JOINT REGIONAL PLANNING PANEL

JRPP No	2014SYE106
DA Number	DA-2015/69
Local Government Area	ROCKDALE
Proposed Development	Integrated Development - Demolition of existing structures and construction of two (2) residential flat buildings (nine and five storeys) comprising a total of 106 residential units over a basement car park podium & rooftop terraces
Street Address	28, 30, 32 Innesdale Road & 25-29 Gertrude Street, Wolli Creek
Applicant/Owner	HH Property Investments Pty Ltd
Number of Submissions	Nil
Regional Development Criteria (Schedule 4A of the Act)	Development that has a capital investment value of more than \$20 million
List of All Relevant s79C(1)(a) Matters	<p>List all of the relevant environmental planning instruments s79C(1)(a)(i);</p> <ul style="list-style-type: none"> • SEPP – 55 – Remediation of Land • SEPP 65 – Design Quality of Residential Flat Development • Residential Flat Design Code • SEPP Infrastructure 2007 • Rockdale Local Environmental Plan 2011 <p>List any proposed instrument that is or has been the subject of public consultation under the Act and that has been notified to the consent authority: s79C(1)(a)(ii);</p> <ul style="list-style-type: none"> • Dra

Figure 4 - Reduced blank end walls

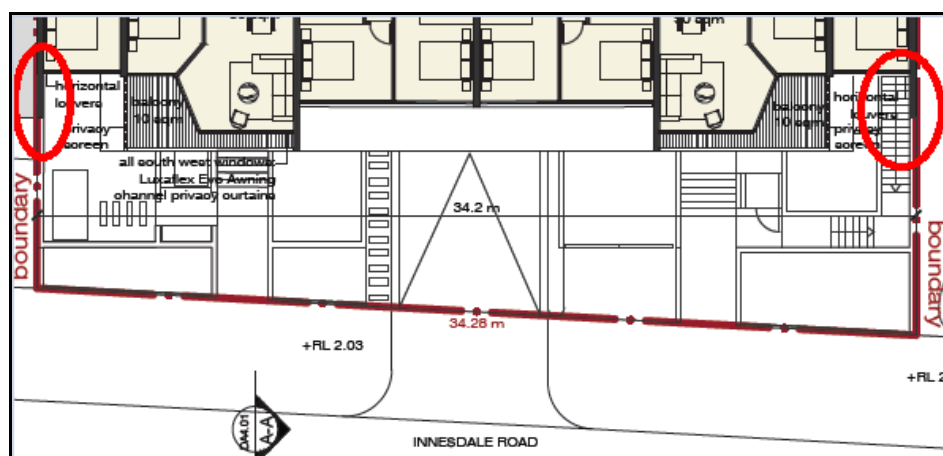
The DRP raised concerns regarding the *“over assertive blank end walls”* which protrude further forward of the building line at eastern and western sides of both buildings. Amended plans indicate a reduction in the lateral extent of these walls, which is now deemed satisfactory.
